APPLICATION NO.	FILING DATE	FIRST NAMED INVENTOR	ATTORNEY DOCKET NO.	CONFIRMATION NO.
10/623,803	07/22/2003	Amold Keller	246472005200	5304
Barry E. Bretse	7590 03/26/2007 chneider		EXAM	INER
Morrison & Foerster LLP Suite 300 1650 Tysons Boulevard McLean, VA 22102			RAMANA, ANURADHA	
			ART UNIT	PAPER NUMBER
			3733	
	-			
SHORTENED STATUTORY PERIOD OF RESPONSE		MAIL DATE	DELIVERY MODE	
3 MONTHS		03/26/2007	PAPER

•	Application No.	Applicant(s)					
	10/623,803	KELLER, ARNOLD					
Office Action Summary	Examiner	Art Unit					
	Anu Ramana	3733					
The MAILING DATE of this communication app Period for Reply	ears on the cover sheet with the c	correspondence address					
A SHORTENED STATUTORY PERIOD FOR REPLY WHICHEVER IS LONGER, FROM THE MAILING DA - Extensions of time may be available under the provisions of 37 CFR 1.13 after SIX (6) MONTHS from the mailing date of this communication. - If NO period for reply is specified above, the maximum statutory period w - Failure to reply within the set or extended period for reply will, by statute, Any reply received by the Office later than three months after the mailing earned patent term adjustment. See 37 CFR 1.704(b).	ATE OF THIS COMMUNICA

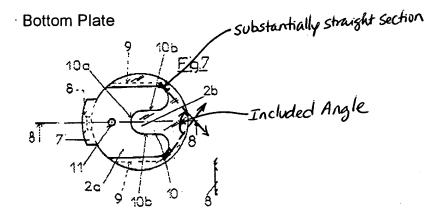
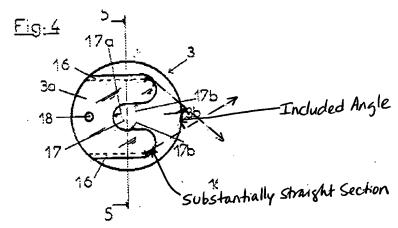
Caenen et al. disclose an intervertebral disc prosthesis including: two cover plates (1, 2) and a prosthesis core 3 connected to cover plate 2 by connection profiles undercut in a complementary manner wherein the connection profiles include at least a pair of substantially straight profile sections, i.e., profile sections that are largely but not wholly straight, disposed symmetrically with respect to an anterior-posterior direction of the prosthesis (Figs. 4, 5, 7 and 8 and pages 5-9 of the attached translation).

It is noted that lines could be extended from substantially straight sections where the undercut portions 9 curve inward such that the lines meet at an included angle not greater than 150 degrees. Similarly, lines could be extended

from substantially straight sections of undercut portions 16 such that the lines meet at an included angle not greater than 150 degrees.

See marked up Figures from Caenen et al. below, to clarify Examiner's interpretation of Caenen et al..
